Preliminary Overall Area Development Plan Lantana Crossing Subdivision

Re: Lantana Crossing POADP

POADP # 641

P.O.A.D.P. REVIEW

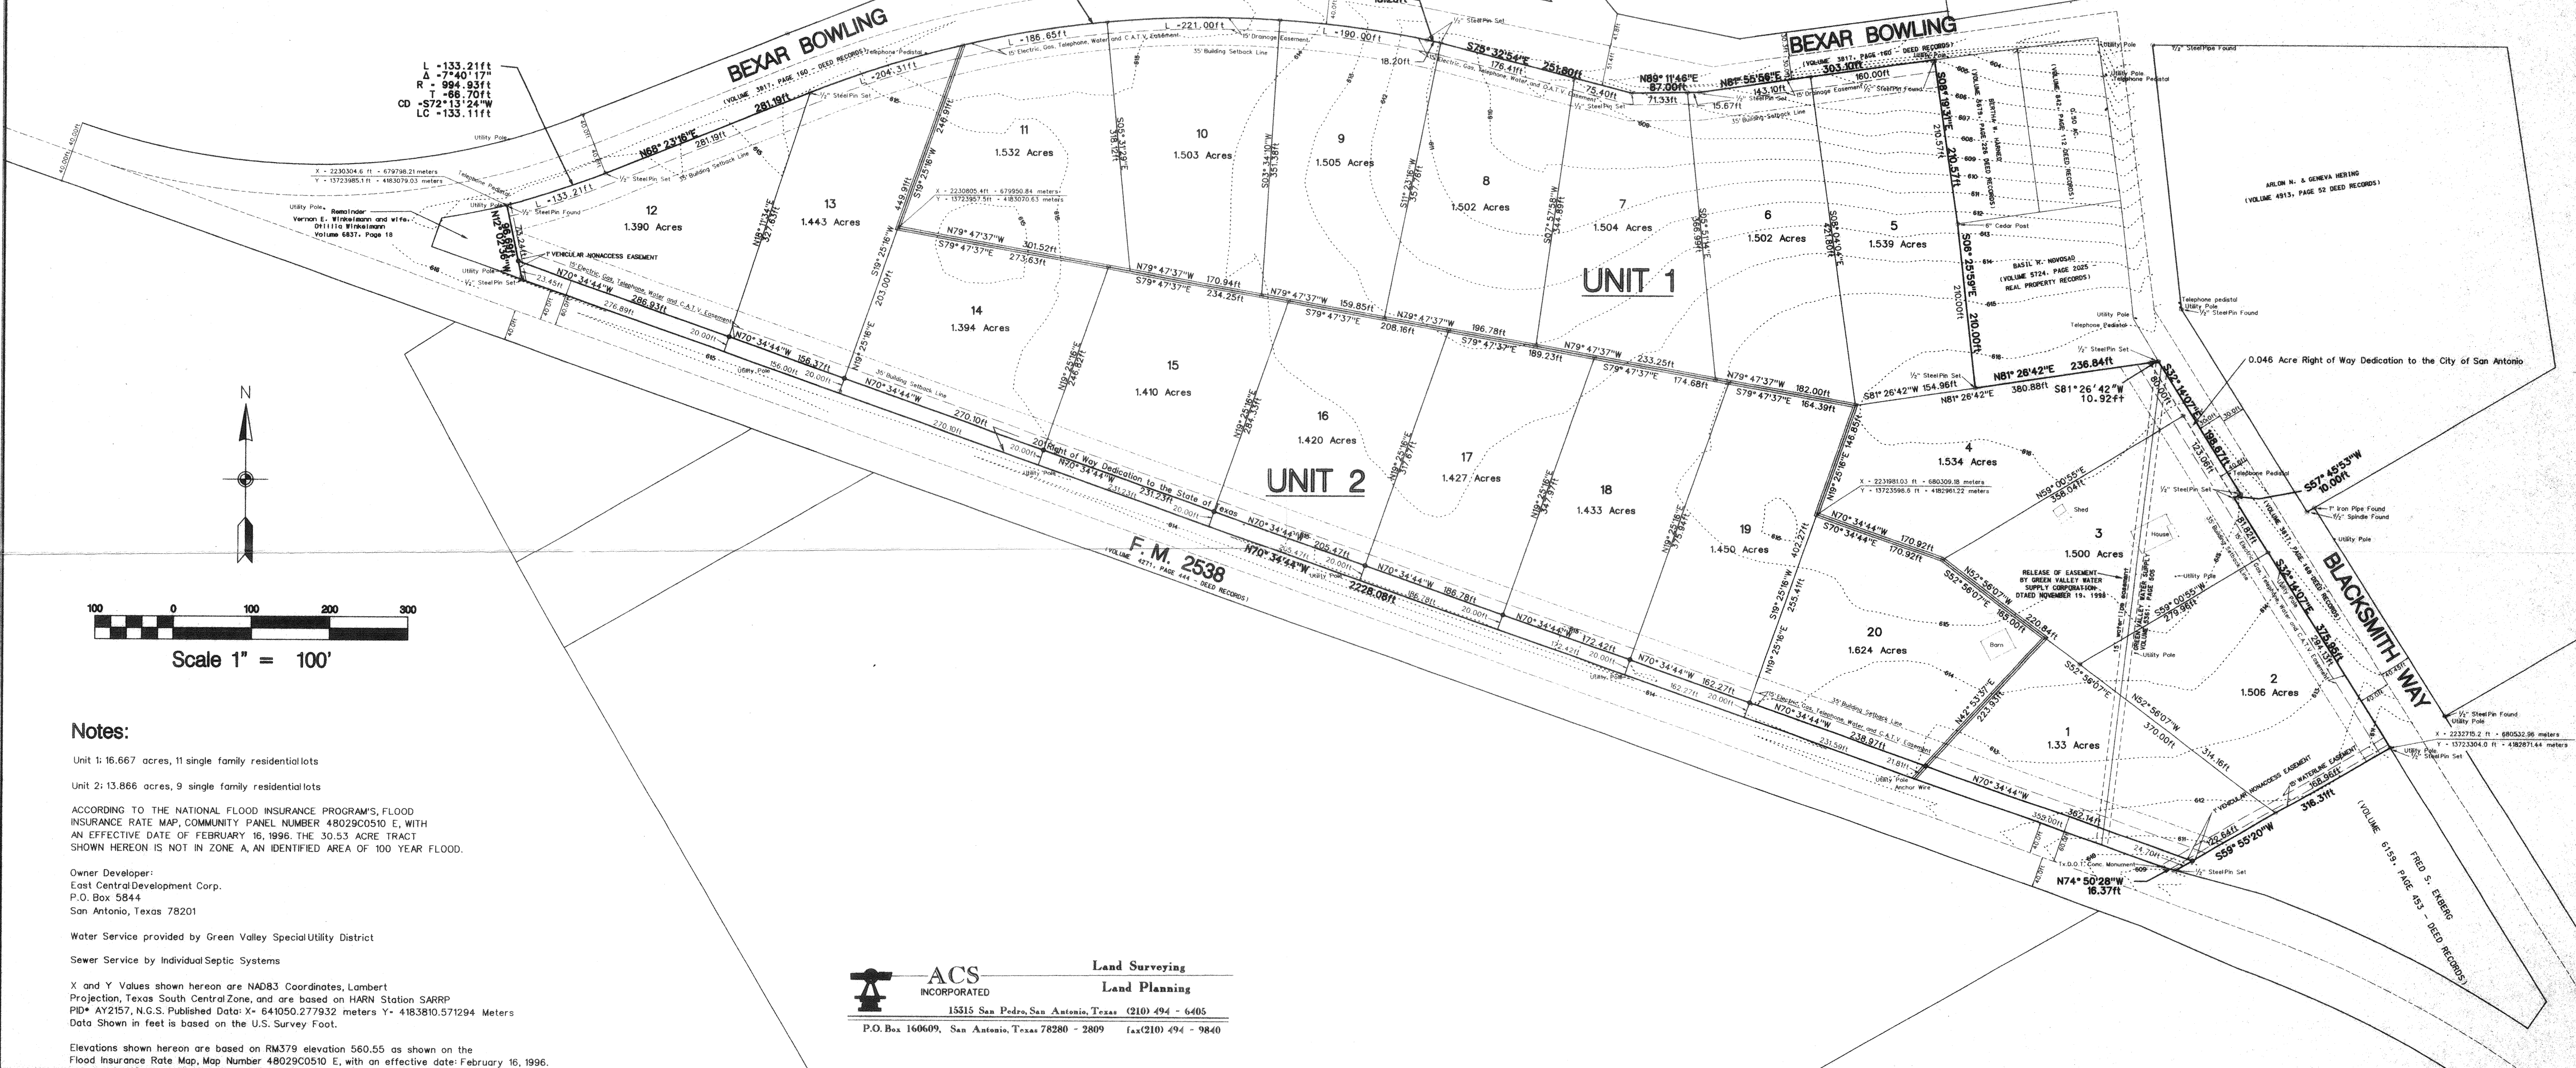
- Based on the topography, a Flood Plain Study and drainage review will probably be required during the platting process.
- In consideration of public safety and convenience, excessive grades by reason of topography should be avoided in street layouts and arrangements.

- Access and R.O.W. issues along State facilities will need to be resolved with the Texas Department of Transportation (TXDOT). For information about these requirements you can contact TXDOT at 615-5814.

- This development will need to comply with tree preservation ordinance #85262. For information about these requirements you can contact Building Inspections at 207-7102.

- It will be expected that you will plat all of the property depicted in your POADP, to include: floodpains, drainage areas and open space.
- I would encourage you to work closely with the school district, so that they can plan accordingly.

- Please note that a one foot non-access easement near the intersection of Bexar Bowling and Trainer Hill Road (FM 2538) will be required.

For residential development directly adjacent to State ROW, the developer shall be responsible for adequate set-back and/or sound abatement.

A dedication of 20' will be required along the entire frontage of FM 2538.

This property is eligible for a maximum combined total of five(5) access points, based on the overall combined FM 2538 frontage. Locations will be as directed by "Regulations For Access Driveways to State Highways".
